4.1 Response to Pre-application

SHH received a response via email from Camden Council officer Nanayaa Ampoma regarding the pre-application scheme (2015/0869). The points discussed are outlined below:

4.2 Proposal - Site

Figure 4.2.1: Proposed street elevation (NTS)

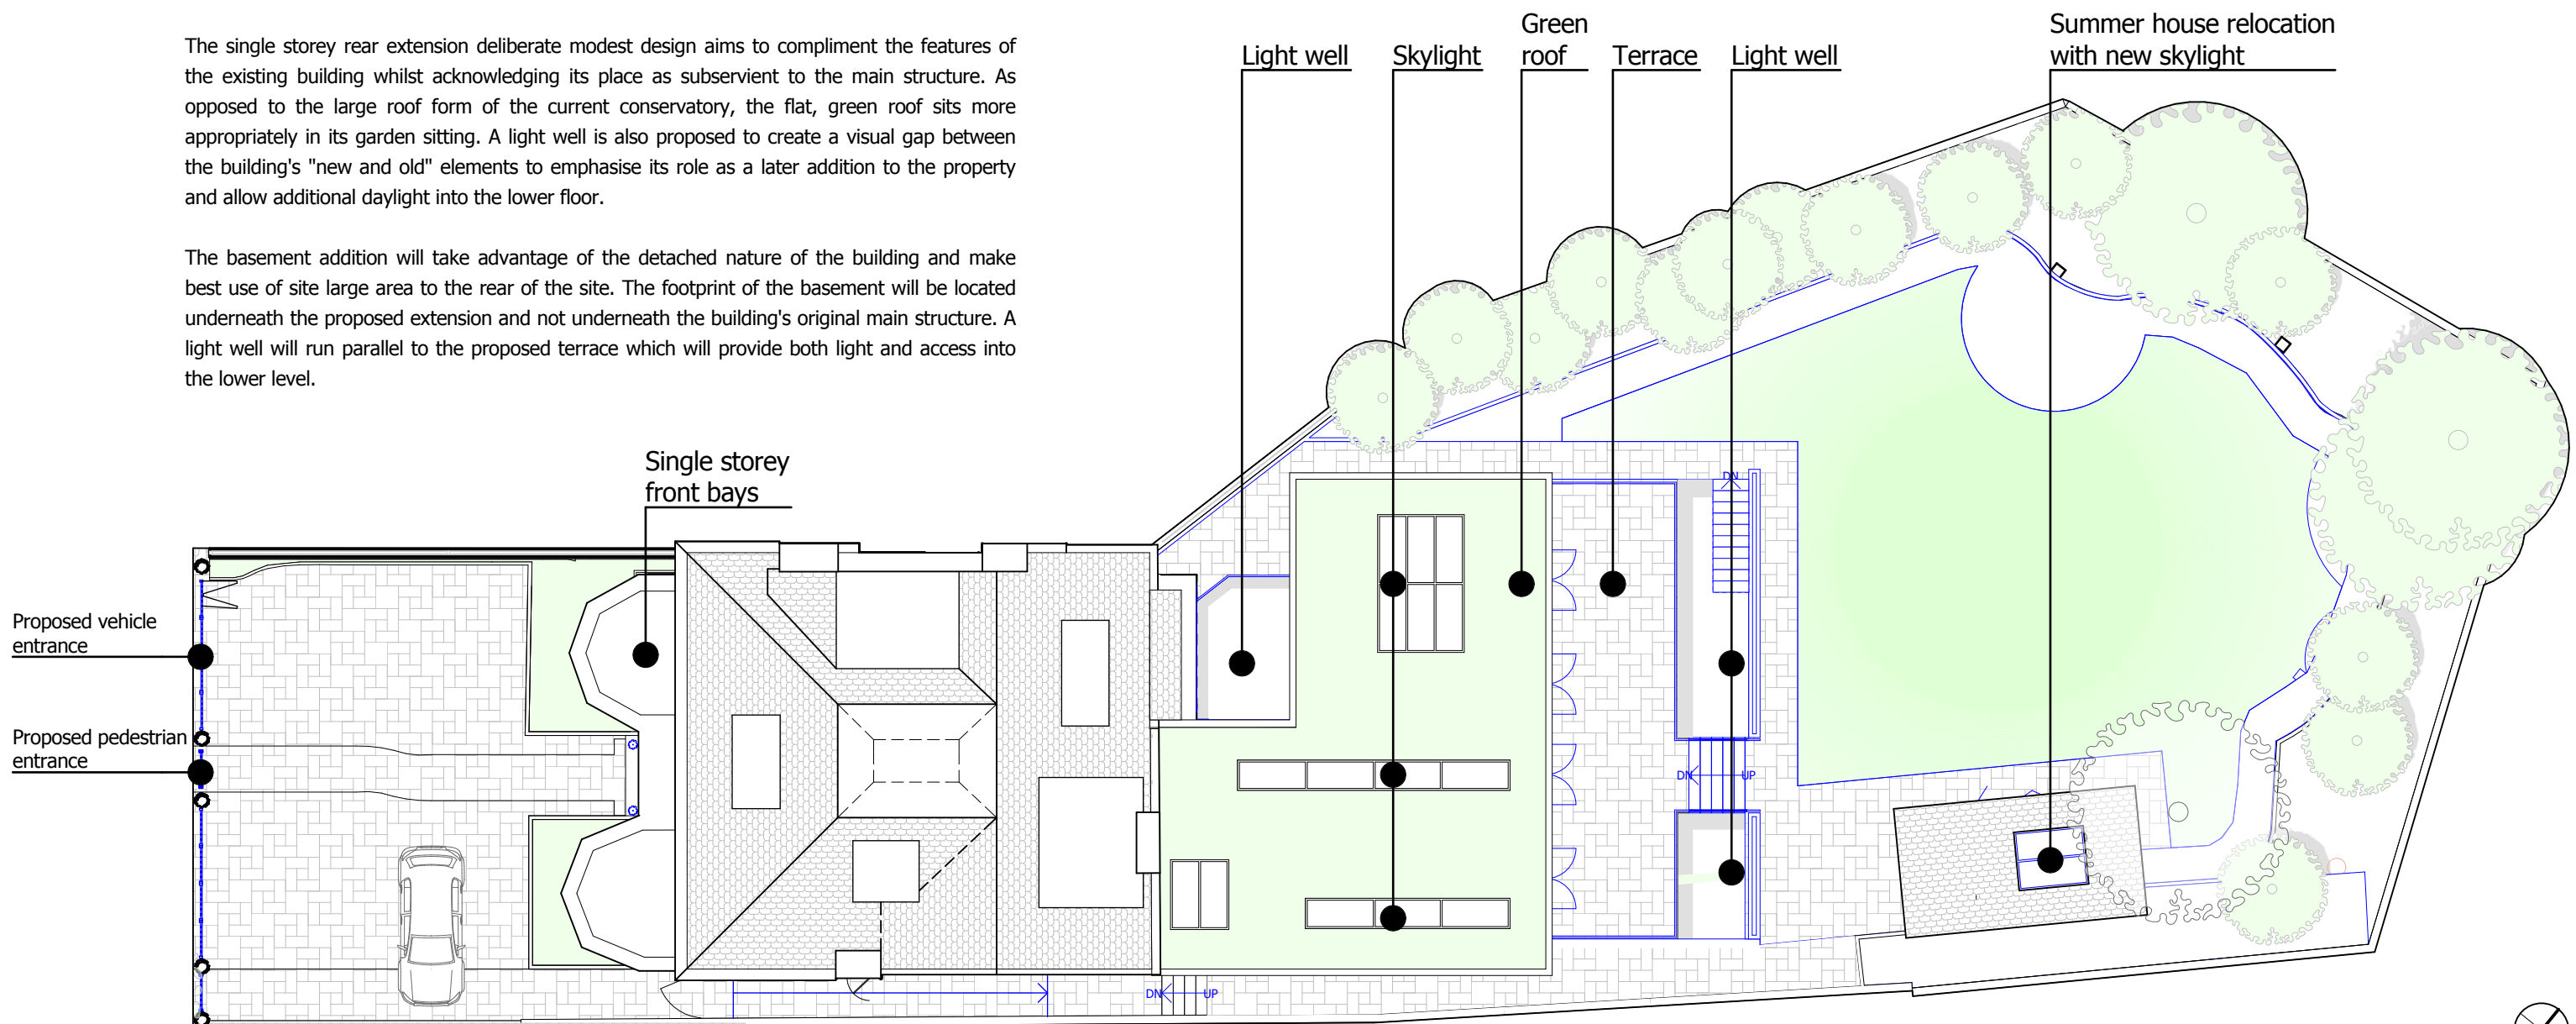
- "The proposed alterations to the property's front elevation is not acceptable given that it is in a conservation area and there is no real benefit to the works in terms of the character of the property. The conservation team have also commented that the proposal would remove original window detailing/style, front entrance and general detailing at roof level. Therefore it would not respect what is there. In addition, the cumulative impact of all the proposed works would mean that much of the property was rebuilt. Some of the drawings show that there would be an alteration to the rear chimneys and that the roof would be raised. However as I spoke to you on site and you confirmed that one would be removed and the other would stay as it, I have assumed that one of the plans is just incorrect. Let me know if I am wrong."

"The conservation area statement refers to the development of Harley Road as being widely recognised as meeting the highest design standards in 1909. The property is part of what has been termed the Willett developments. The conservation appraisal states "the Willett development forms an important and unmistakeable group within the Conservation Area that cannot be understated.basement (p:21). The conservation appraisal highlights no.9 as a Positive Contributor (p:66). There is a strong presumption in favour of protecting those buildings that make a positive contribution to the area. In light of this we are unlikely to support the proposed works."

As per the comments above, the changes proposed to create 'hexagonal' front bays and the rearrangement of the first floor windows have been removed from this application. The proposed minor changes to the 'sharp' entrance portico and the second floor dormer have remained in this application and these elements have adopted curved features to soften the overall front facade. Please refer to the 'Design Approach' page of this document for further details. No changes are proposed to the existing chimneys.

Figure 4.5.1: Proposed plan of Lower Ground Floor (NTS)

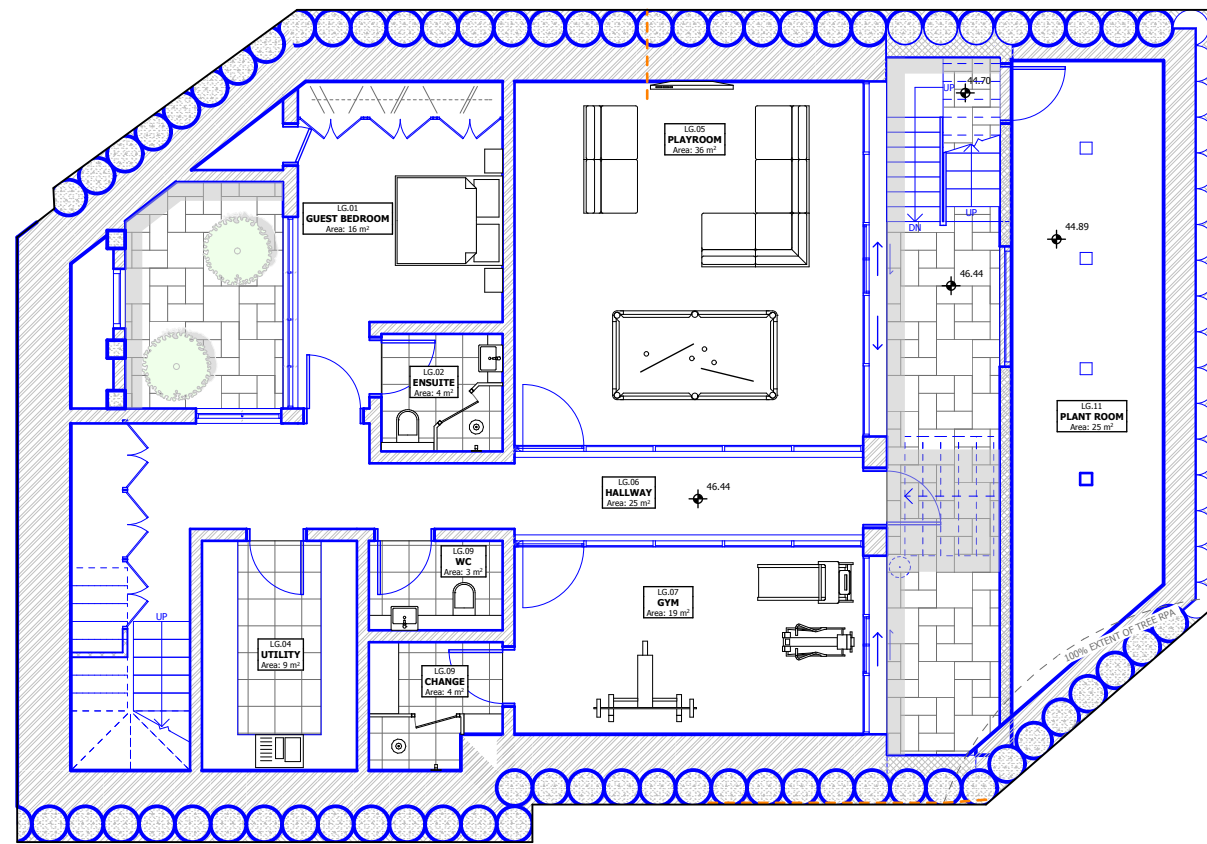
- "Basement is likely to be acceptable subject to the submission of a Basement Impact Assessment that passes the independent verification process. Please note that your client would be liable for the fees for the independent assessment which ranges from 2000-4000. The allocated officer would normally gain a few quotes and then your client would choose which company to use. There may be further follow up assessments as well for any additionally information required. This can extended the application process by 4 weeks."

- "Plant room will require the submission of a noise assessment to show that any noise would not affect neighbouring properties or future occupants."

The basement footprint has be slightly altered around the proposed plant room to avoid the root protection area of the neighbouring tree at 3 Wadham Gardens. Please see the accompanying "Arboricultural Impact Assessment" and architectural drawing "(680)020_PL01" for details. A basement impact assessment and ground movement analysis have both been carried out and accompany this application.

An acoustic report can be found accompanying this application.
